MIL-C-39012C
AMENDMENT 4
7 June 1990
SUPERSEDING
AMENDMENT 3 -
5 December 1988

MILITARY SPECIFICATION
CONNECTORS, COAXIAL, RADIO FREQUENCY,
GENERAL SPECIFICATION FOR

This amendment forms a part of MIL-C-39012, dated 11 August 1982, and is approved for use by all Departments and Agencies of the Department of Defense.

FIGURE 6. Safety wire hole pullout procedure.

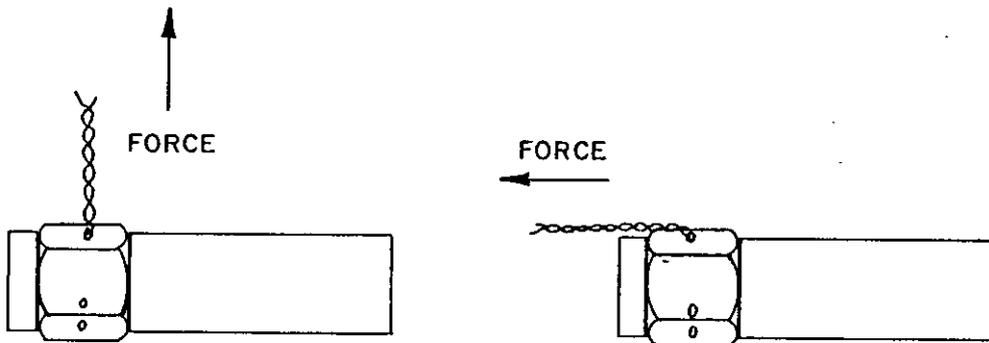
Add 4.6.25 as follows:

"4.6.25 Safety wire hole pullout (see 3.32). A single strand of safety wire shall be looped through the safety wire hole and secured to itself. Forces of 15 pounds (67 newtons) minimum shall be applied to the safety wire pulling away from the connector. One pull shall be parallel to the connector axis and one pull perpendicular to the connector axis (see figure 6). The safety wire shall be corrosion resistant steel .020 inch diameter (24 gauge) or .015 inch diameter, (27 gauge) in accordance with MS20995. This test is to be conducted under static conditions. All holes are to be tested individually."

Add figure 6 as follows:
